Site Plan Review

(3210 Glynn Avenue)

Planning, Development, & Codes

November 8, 2023

SITE PLAN FOR ISLAND VIEW
RESIDENTIAL AND COMMERCIAL DEVELOPMENT
CITY OF BRUNSWICK, GEORGIA
PREPARED FOR:
MARITIME HOMES, LLC.

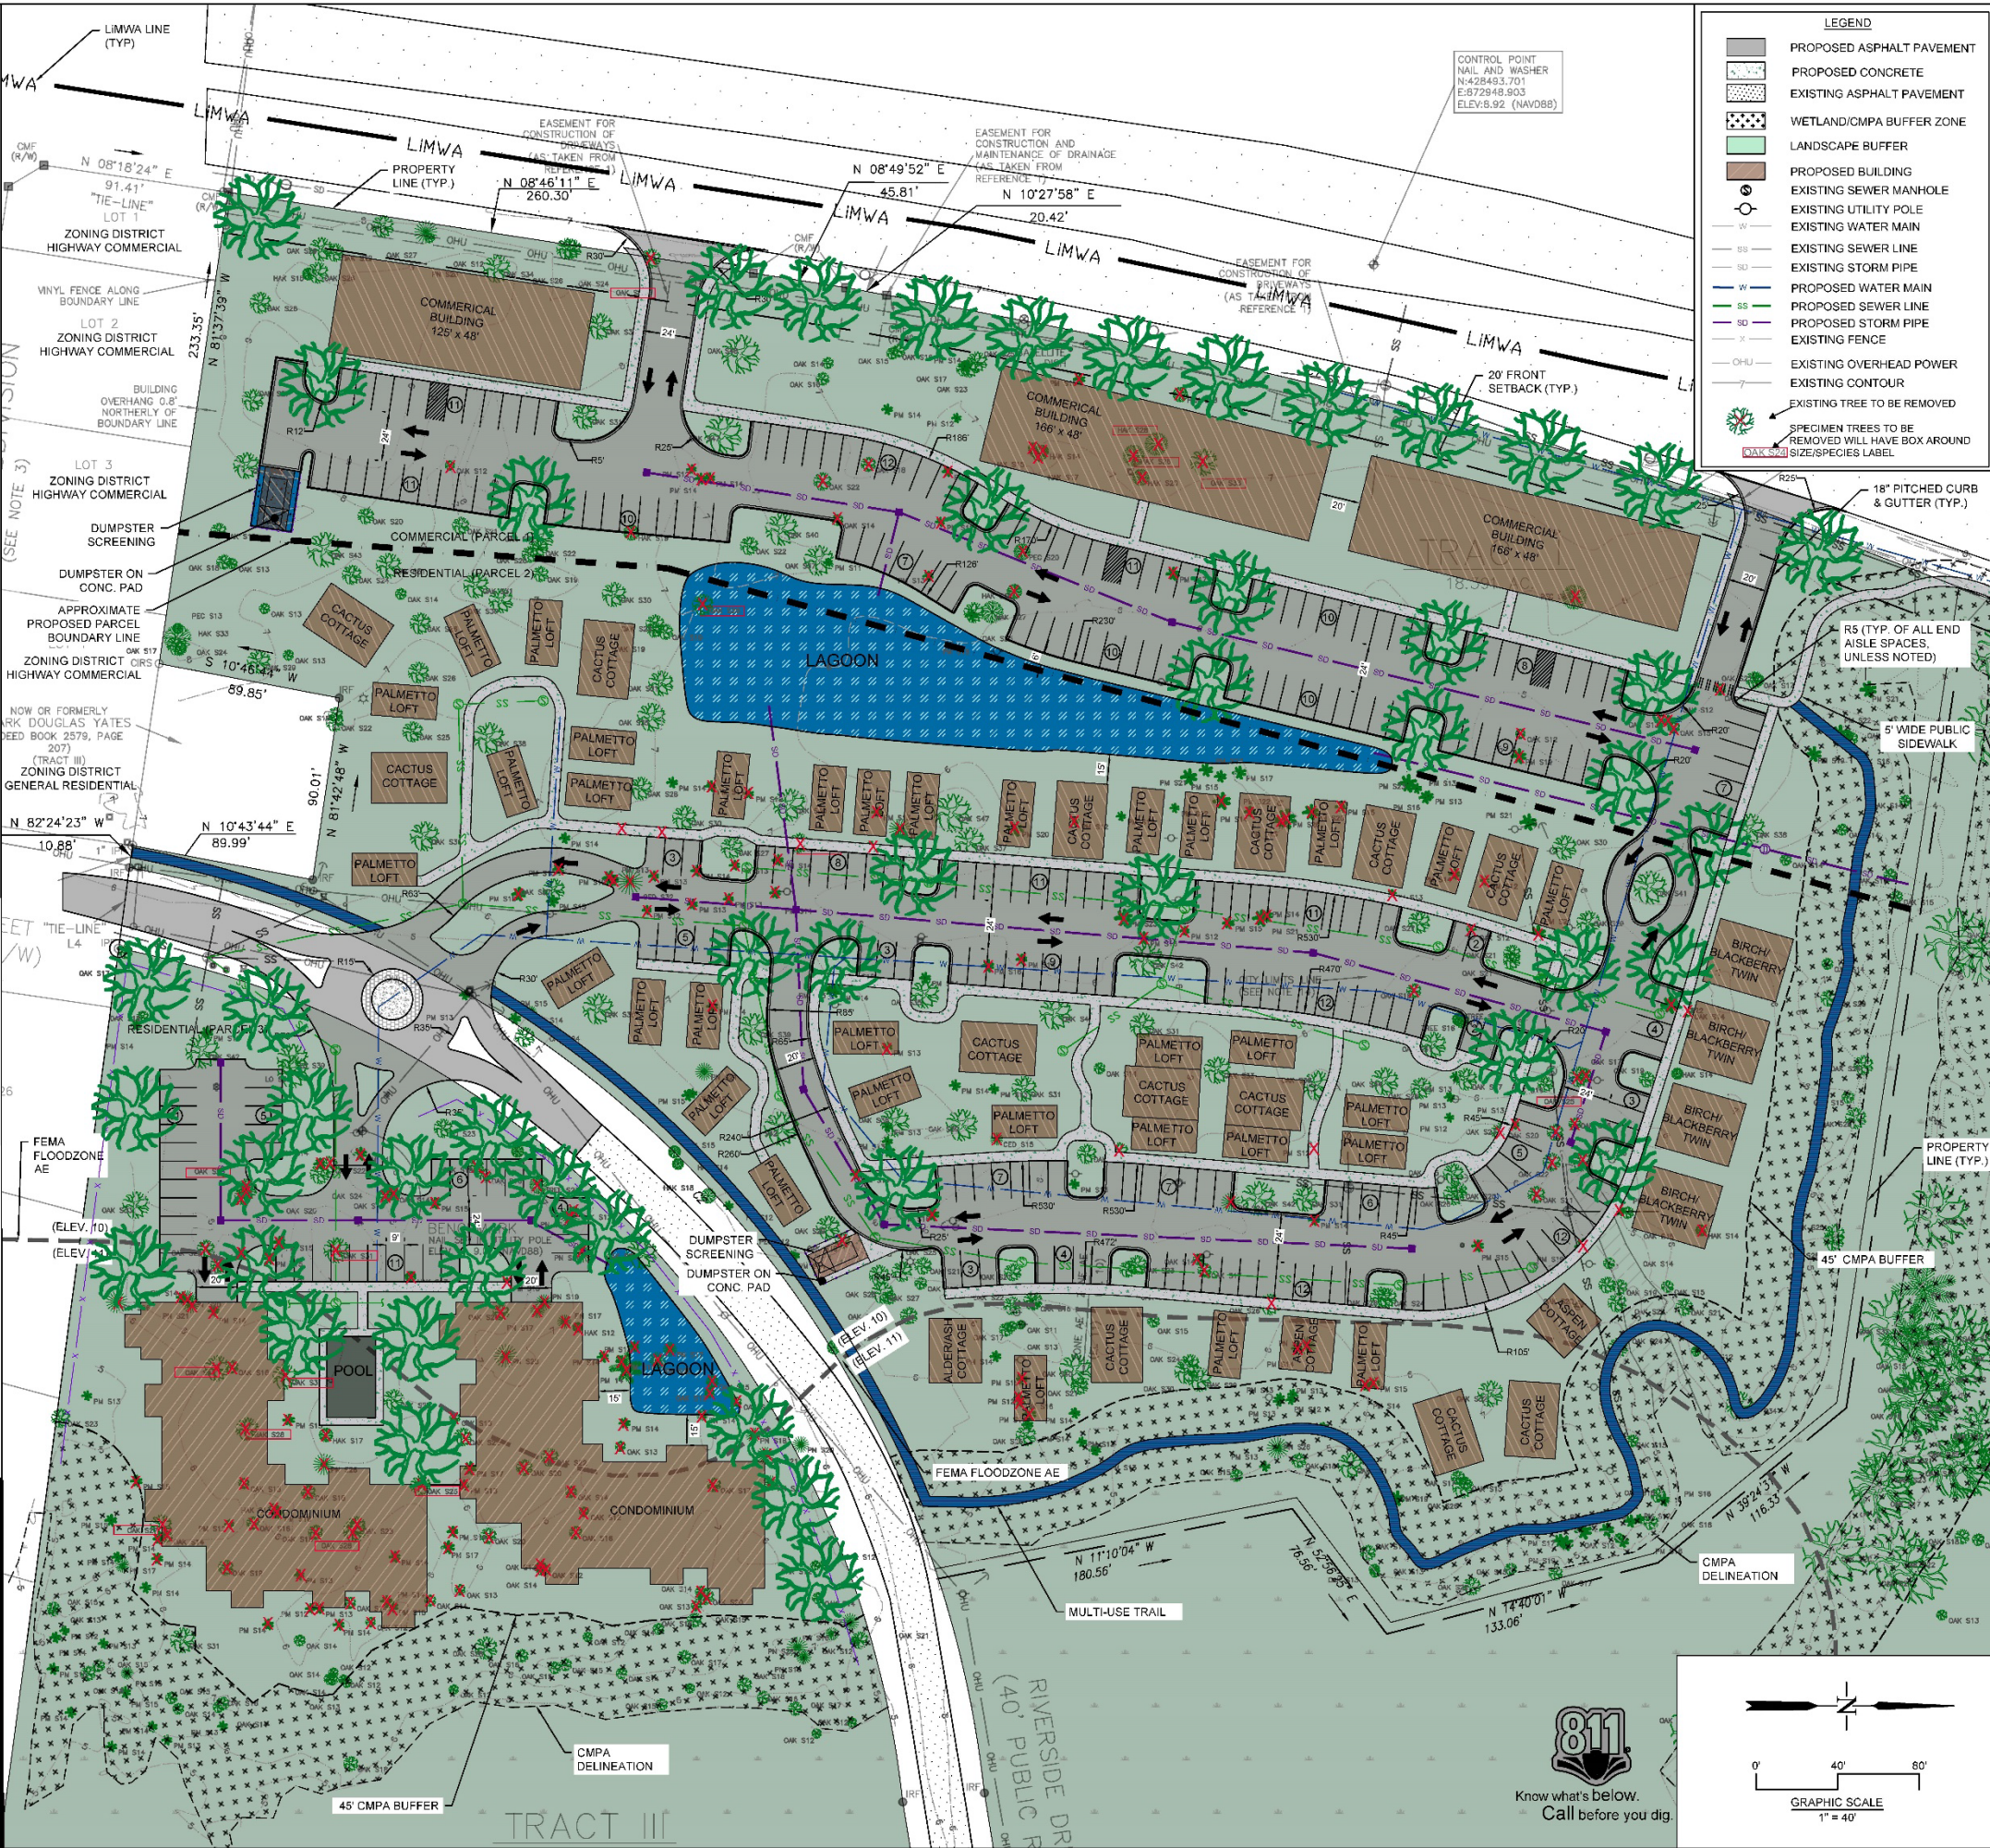
- LiMWA line -- This is the Limit of Moderate Wave Action. Any development on the east (seaward) side of this line must comply with V-zone regulations. This is discussed in Section 11-55 of the ordinance, and is reflected on the site plan. The impacts on building design and site conditions will be reviewed as a part of the building permit approval process.

- Freeboard requirement – The ordinance includes a one-foot freeboard requirement. Any of the development in the AE-10 zone on the landward side of the LiMWA line must have a FFE of 11.0 or higher. This requirement will be confirmed during the building permit approval process.

- Storm Water – Site plan reflects consideration of collecting storm water from impervious surfaces and detaining on site. Collection calculations, any required permits, etc. will be reviewed, verified and approved by the City Engineer prior to issuance of a building permit. Depth of detention may require fencing.

7) Fire Access: Fire Marshal has reviewed and believes the current plan provides adequate access for equipment, other than the "tree split" at the northern. Suggested relocating planned planted tree, widening the northern arm and converting the adjacent parking to a Fire Access Lane.

3) 45' Marsh Buffer: Is reflected in the plan. Only amenity provided within the setback is a pedestrian path. This meets the requirements of the GADF.
